Suspension - Front End Thumping Noise on Bumps

Order No.: P-B-32.25/07a

Supersedes: P-B-32.25/07 dated September 2001

Thumping Noise from Front Axle Area While Driving Over Bumpy Road

Figure 1

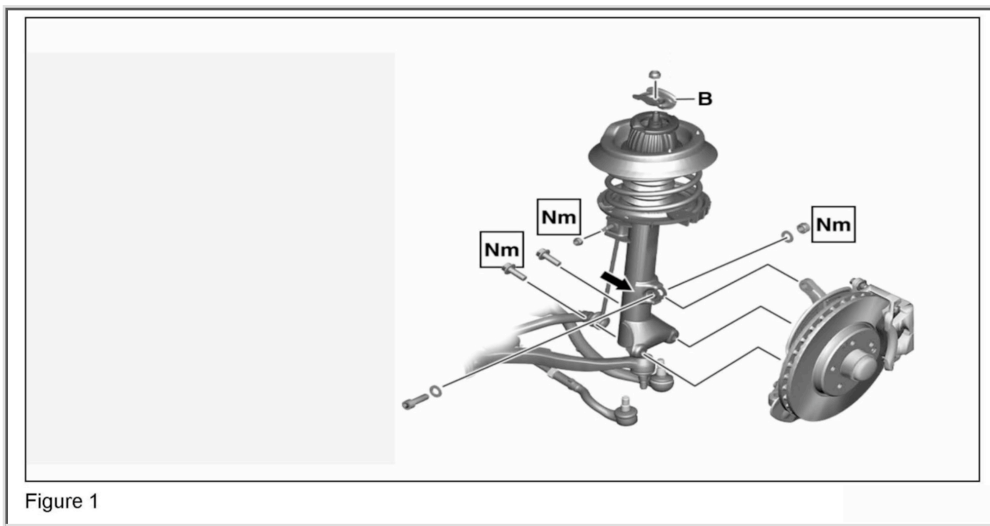
If you receive customer reports in the above model vehicles of a thumping noise occurring from the front axle area while driving over bumpy roads, it is possible that the clearance between the rebound stop (Figure 1, B) and the rubber ring on the top of the front damper strut is too small.

Figure 2

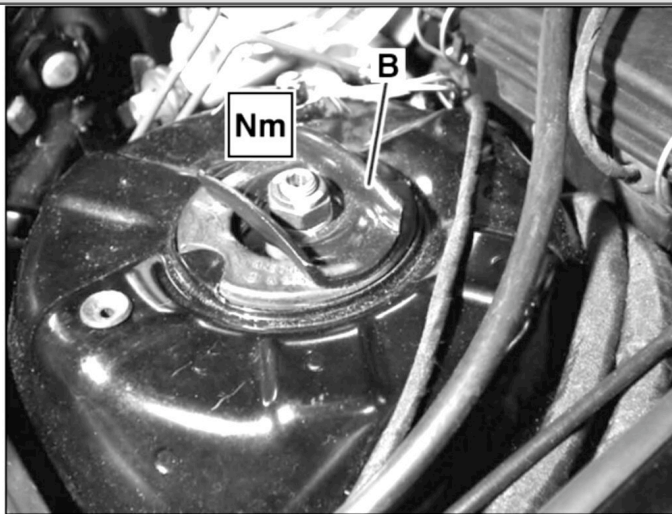
4. Measure clearance between the rebound stop (Figure 2, B) and the Rubber ring. If the clearance is below 1 mm, then the rebound stop (Figure 2, B) must be replaced.

5. Remove the 21 mm nut which secures the rebound stop to the damper strut assembly.
- Note:** It is not necessary to remove the damper strut assembly.

6. Replace the removed rebound stop with a new rebound stop.
 7. Secure the new rebound stop with a new 21 mm nut. Refer to WIS document AR32.25-P-1018P for the torque value for the newly installed 21 mm nut.
